CUI DEVICES

Product Change Notice (PCN)

PCN Number: PCN-0539028R-01

Product(s) Affected: CBL-UA-MB-1

Description of Change: Adjustments shown in below images:

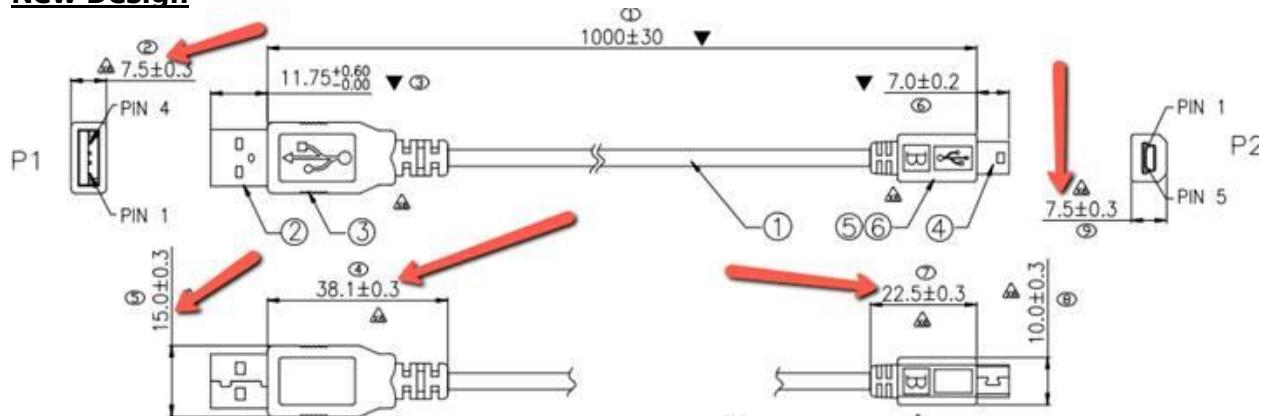
Reason(s) for Change: Old overmold mold cannot maintain efficient production. Adjustments necessary for efficiency purposes of automated production.
